Voluntary Emissions Recall Campaign 11E-A03: Replace the SCR Mixer

E70 and E90 with the M57Y engine

Produced from February 2010 to September 2010

Replace the mixer (Repair instruction 18 31 140).

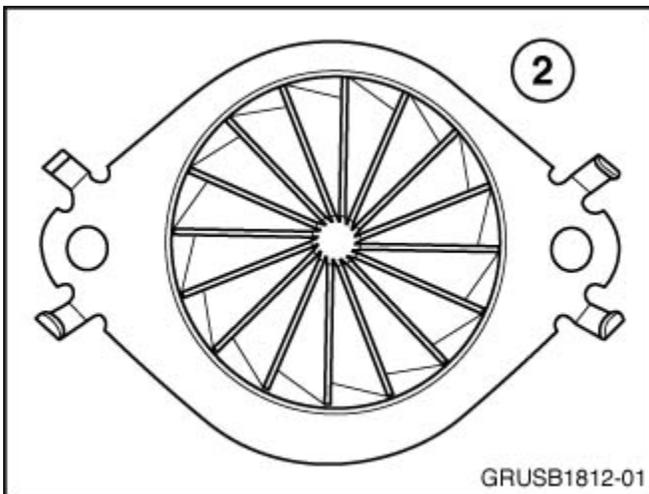
The original style mixer has a multiple fin arrangement (1). This mixer will need to be replaced with P/N 18 30 8 513 445 (E70) or P/N 18 30 8 512 438 (E90).

The updated mixer has one set of fins (2).
